IREDELL COUNTY HEALTH DEPARTMENT

(SEPTIC TANK) IMPROVEMENTS PERMIT AND CERTIFICATE OF COMPLETION

OWNER OR CONTRACTOR Larry Hildreth DATE May 21, 1990 PERMIT NO. ZP-6-A-60

Plot of System Big Indian Loop

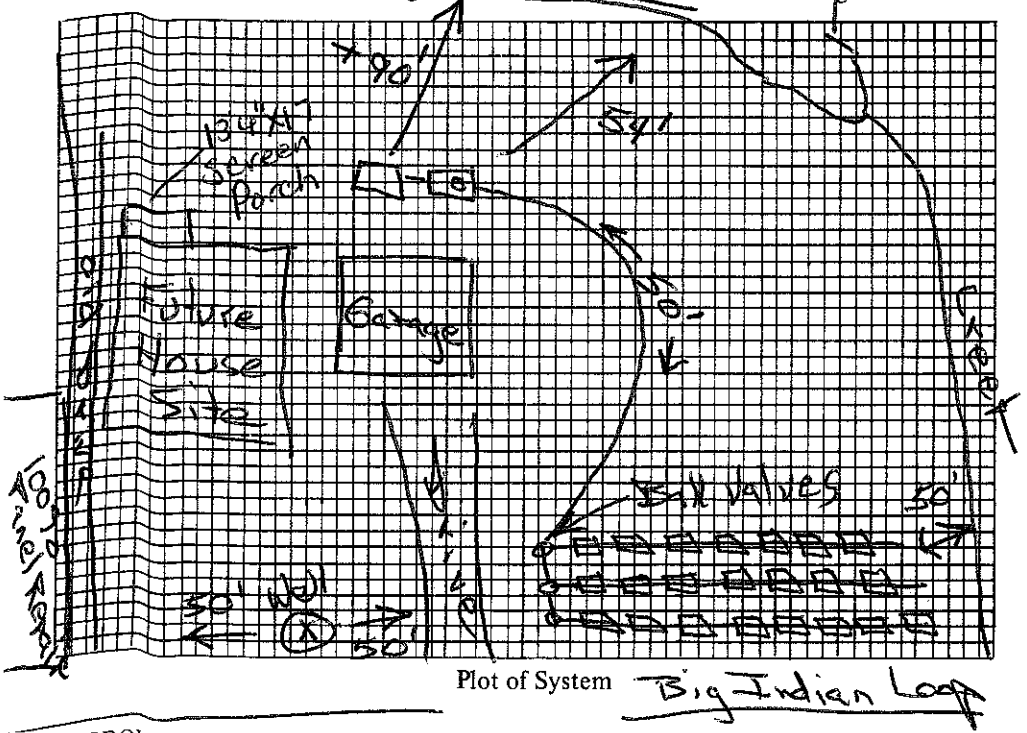
The proposed / existing Screen Porch addition does not appear to impact the existing septic system

**NOTE: Building Addition must be at least 5ft from Septic
